**PLANS AND DOCUMENTS
referred to in the PDA
DEVELOPMENT APPROVAL**

**RE: 820 Greenbank Road, North Maclean
Conceptual Site-Based Stormwater Management Plan (CSBSMP) Addendum Letter**

Industrial Subdivision
820 Greenbank Road,
North Maclean
12 Lot Subdivision (20.25 ha)
Lot 2 on RP 868726

Post Development Catchment Plan

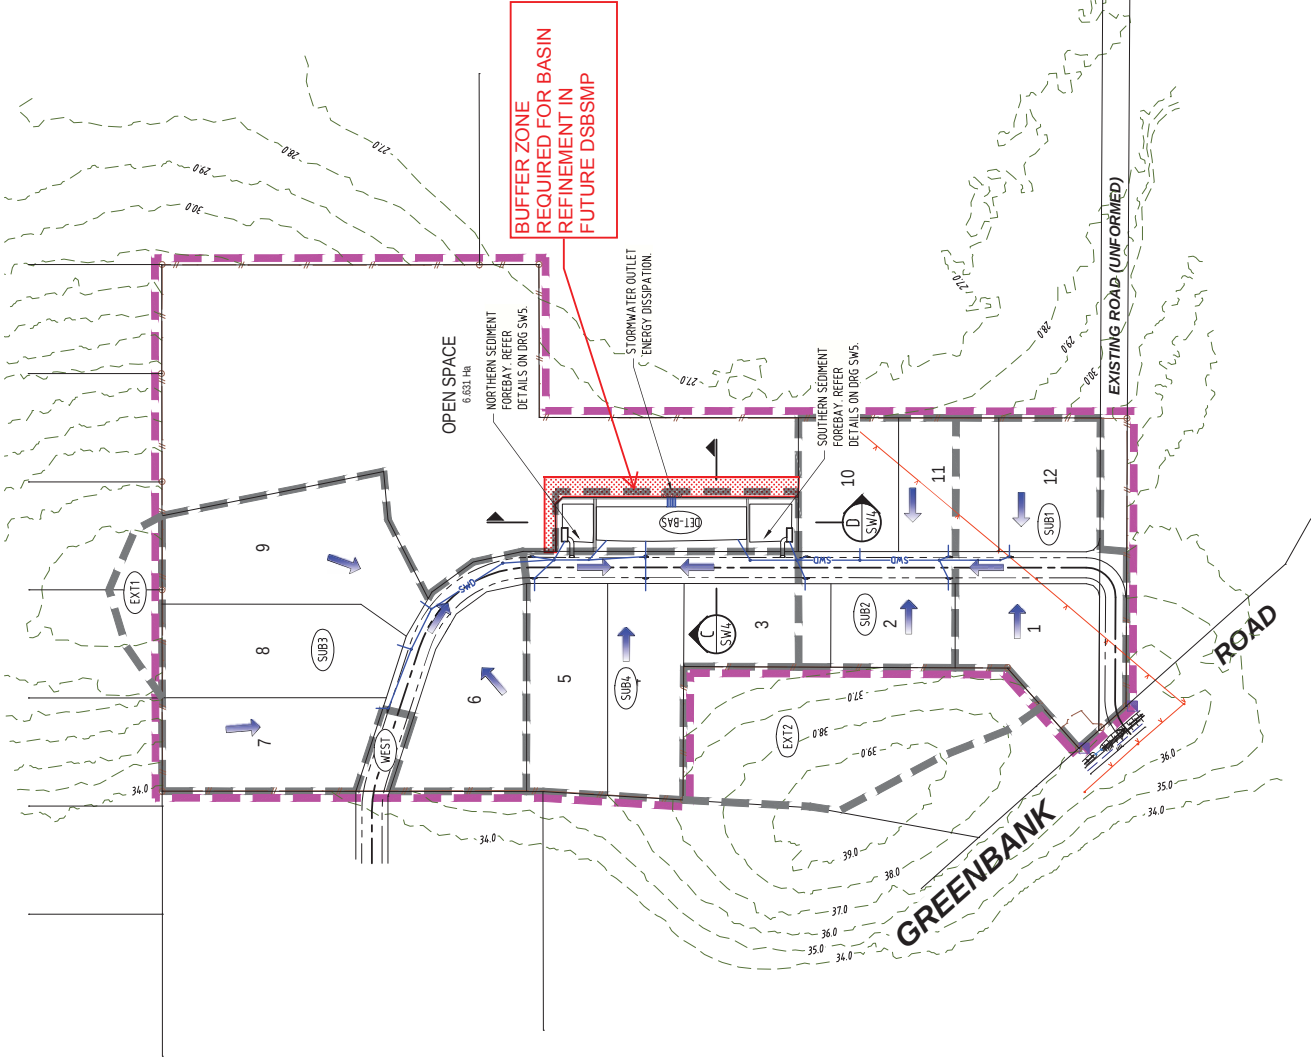
In order to better assure that the land allowance for the stormwater treatment basin is captured for the development application we have reviewed the layout of the basin and would like to nominate a further 'buffer' of 15m along the eastern boundary and 10m along the northern boundary which takes into account the following:

- Allowance for basin floor cross-fall at 1 in 100 to ensure no ponding nuisance
- Floor width increase of 5m to offset loss of storage due to the basin floor grading, further refinement of the bio-retention arrangement and also to add contingency for storage that may be necessary as a result of the more detailed analysis for the DSBSMP as detailed in the above set of dot points
- Widening of the berm to 3m for maintenance access
- Width allowance for the retaining wall
- Width allowance of 6m for a maintenance track along the boundary and energy dissipation rock outlets

A marked up plan and cross section is attached to this letter for a visual explanation.
